ENHANCED VAPOR RECOVERY

Minimizing Wintertime In-Station Diagnostic System Overpressure Alarms

December 4, 2017

NEW RECOMMENDATIONS TO MINIMIZE WINTERTIME IN-STATION DIAGNOSTIC (ISD) SYSTEM OVERPRESSURE ALARMS FOR ASSIST PHASE II SYSTEMS

Figure 1: EOR and Previously Certified Spout Assembly (horizontal view)

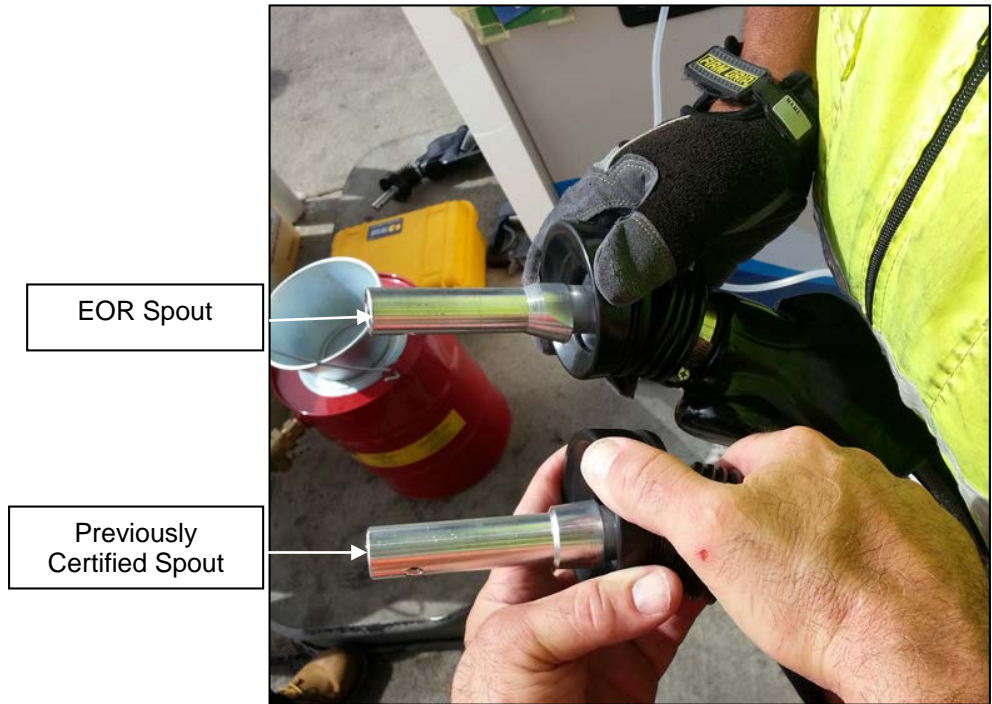
In response to these findings in 2015, Franklin Fueling Systems (FFS), manufacturer of the assist system, made design enhancements to the spout assembly of the assist nozzle. These improvements enable a better seal between the nozzle's vapor collection boot and the vehicle fill pipe, thereby reducing excess air ingestion. The new spout assembly, referred to as Enhanced ORVR-Vehicle Recognition (EOR), is depicted in Figures 1 and 2 and can be field retrofitted onto existing nozzle bodies. During the winter of 2016/2017, CARB staff evaluated the performance of the EOR spout assembly at eight GDFs, each with

differing operating conditions. On August 23, 2017, the new spout assembly was certified by CARB per "Revision V" of Executive Orders [VR-201](#) and [VR-202](#). Although CARB certified the EOR spout assemblies, either field retrofitted or factory new nozzles, CARB staff determined that the factory new nozzles outperformed field retrofitted nozzles and therefore, suggest installation of factory new nozzles.

1. Replace existing assist nozzles with the new (factory assembled) nozzles equipped with the EOR spout assembly according to Section 2 of the CARB Approved Installation, Operation and Maintenance Manual (IOM) for the assist system. The new EOR nozzles are anticipated to be available from FFS in January 2018.
